#10-05-23-002: Front Brake Squeak Noise on Brake Apply (Replace Front Brake Pads) - (Mar 25, 2010)

Models: 2010 Chevrolet Camaro SS
Built Prior to VIN Breakpoint A9172924

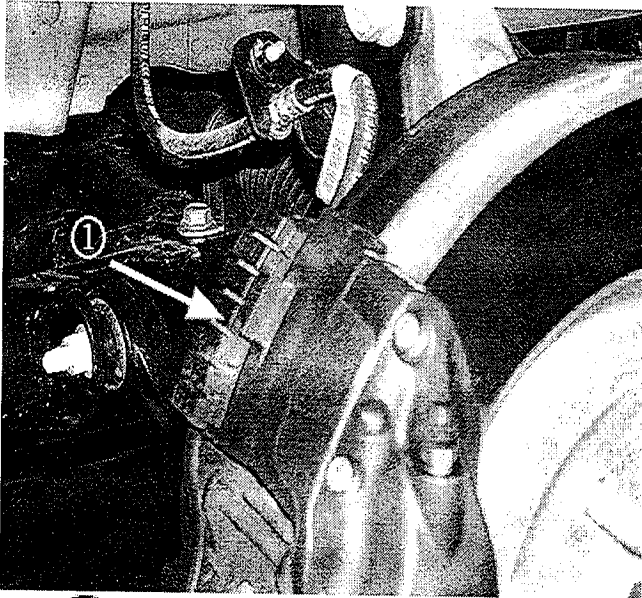
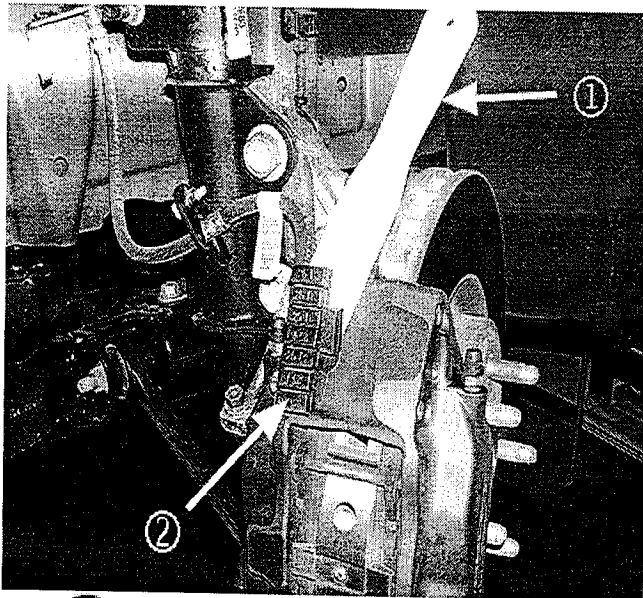
Note: New front brake pads have been released to correct this condition. When installing the new front brake pads, you must remove the factory-installed weights from the front brake calipers.

1. Replace the front brake pads with the replacement kit listed in the parts table below. Refer to Front Disc Brake Pads Replacement (L99, LS3) in SI.
2. Remove the factory-installed weights from the front brake calipers.

- 2.1. Apply penetrating oil (i.e. WD-40® or equivalent) to the weights (1) on both the right and left sides and allow the oil to set for a few minutes.

- 2.2. Use a plastic scraper (1) to remove the weights (2).
- 2.3. Clean any remaining adhesive residue from the calipers using Kent Automotive Acrysol™, P/N 20005, or 3M® General Purpose Adhesive Cleaner, P/N 08984, or the equivalent.
